MEMORANDUM

SUBJECT: ZC 08-33C – Final Report - Modification to approved Planned Unit Development-
(Conference Center Associates I, LLC) (Parcel 121/31)

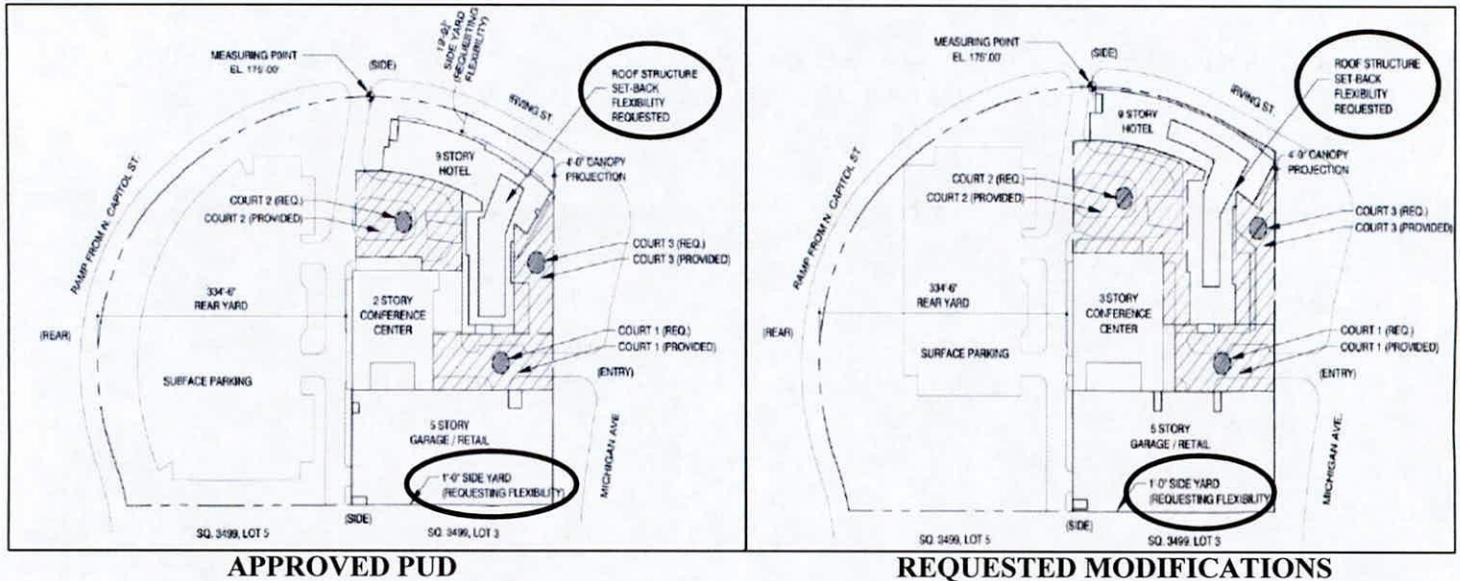
The subject application proposes modifications to the approved PUD involving some design changes to buildings identified in current submissions as the conference center, the hotel and the garage/retail building, as submitted by the applicant as Exhibit 1 through 1D, reflecting 13 changes including:

- An increased height of the retail space from 16 feet to 24 feet;
- An increased height of the conference center ballroom from two stories to three stories;

- An increased depth of the conference center to create a connection to the hotel;
- An addition of a roof terrace level into the conference center;
- A shift in the hotel building to the property line at Irving Street;

- An increased basement footprint of the hotel to match the building's footprint above;
- A modified penthouse structure to accommodate the hotel's extension to the property line;

- A modified the landscape on Irving Street to accommodate the hotel's extension to the property line
- A relocated restaurant entrance adjacent to the hotel's entrance;

- A reduced footprint of the temporary surface parking lot from 200 spaces to 98 spaces. The spaces (102) would be accommodated in the basement of the parking structure. The approved 600-space count would be maintained;

- A two-story glass walkway connection (formerly a metal enclosure) between the parking garage and hotel/conference center; and
- An adjusted hotel's footprint to accommodate a new hotel brand's design requirements with minimal changes to the FAR from 1.46 FAR to 1.63 FAR, and lot occupancy from 31% to 36%, as highlighted subsequently.
